Subject: POPPING AND/OR SQUEAKING NOISE FROM FRONT SHOCK ABSORBER AND/OR CREAKING NOISE FROM FRONT LOWER ARM BUSHING	Bulletin No: 02-005/17
	Last Issued: 01/13/2017

This bulletin supersedes the previously issued bulletin(s) listed below. The changes are noted below in Red beside the change bars.

Protector Installation

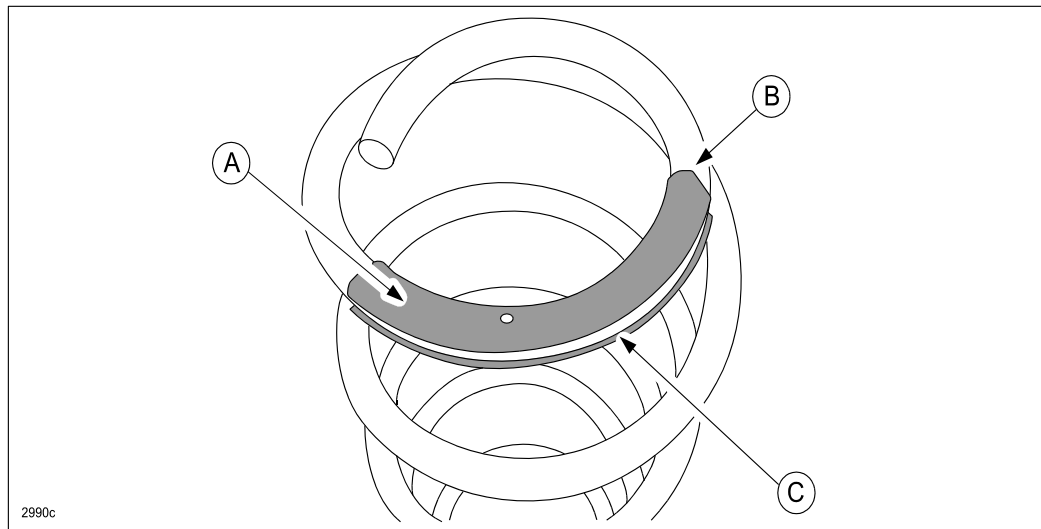
5. Install the protector (A) onto the coil spring aligning the end (slant cut side) with the marking at spot (B).
NOTE: Install the protector so the gap (C) is evenly aligned around the outer edge of the coil spring.

Bump Stopper Replacement

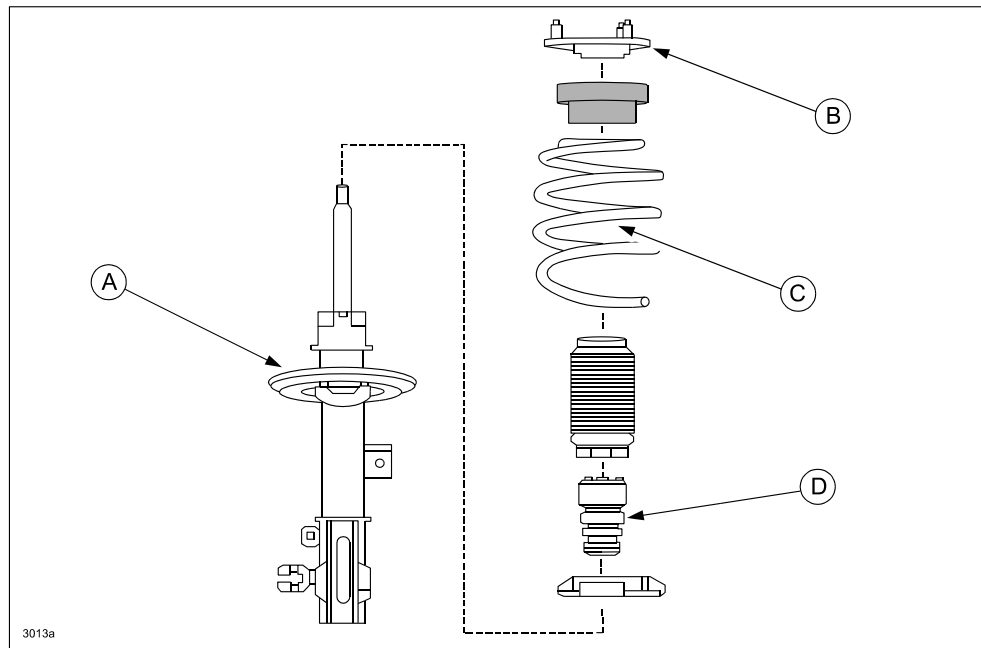
1. Replace the bump stopper with the modified one according to MS3 online instructions or the Workshop Manual (section 02-13 FRONT SHOCK ABSORBER AND COIL SPRING DISASSEMBLY/ASSEMBLY).

- Before removing the mounting rubber, mark its original position so it can be re-installed later to the same position.
- When replacing the bump stopper with a modified one, apply grease to upper side of the bump stopper and to the inside of the bump stopper (on the surface that contacts the damper rod).

Lower Arm Bushing Replacement

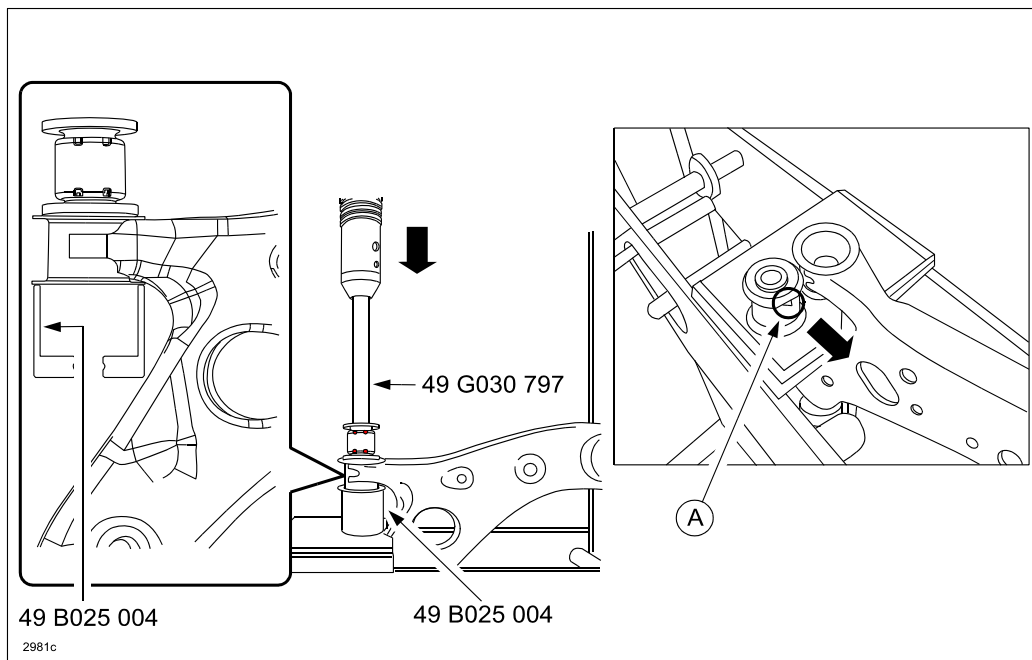
- Before installing the new bushing, wipe the inside of the outer tube and make sure it is clean.
- Apply soap suds to the bushing to ease the installation.
- Always wipe off soap suds from the front lower control arm and bushing with a cloth.
- Install the bushing so the projection (A) is pointing toward the front of the vehicle.

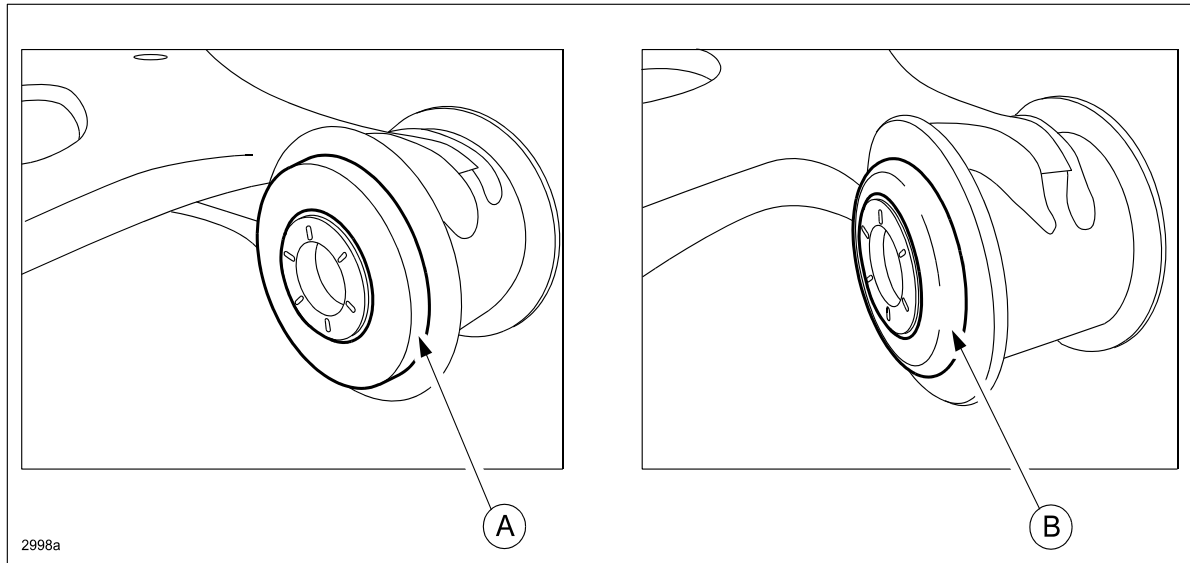
CAUTION: Make sure the bushing has been properly inserted by verifying that the bushing tab **IS FULLY EXPANDED**, as shown in the illustration to the left (A). The illustration to the right (B) shows an example of a bushing tab that **IS NOT FULLY EXPANDED**.

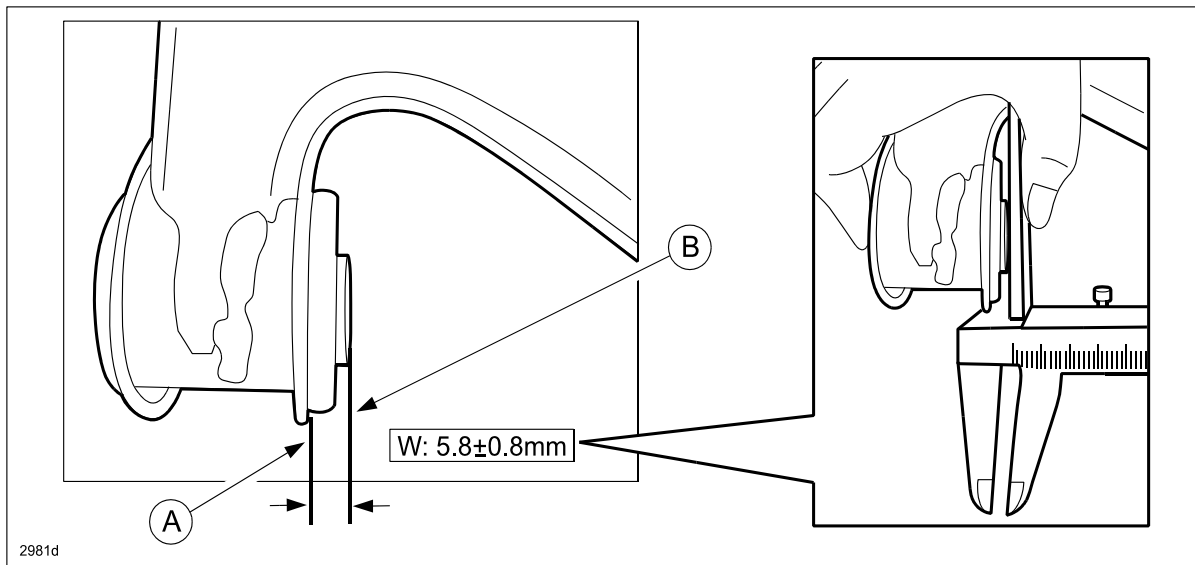
5. After installing the bushing, verify the distance between the front lower control arm (A) and front lower control arm bushing inner pipe (B) equals $5.8 \pm 0.8\text{mm}$ as shown below.
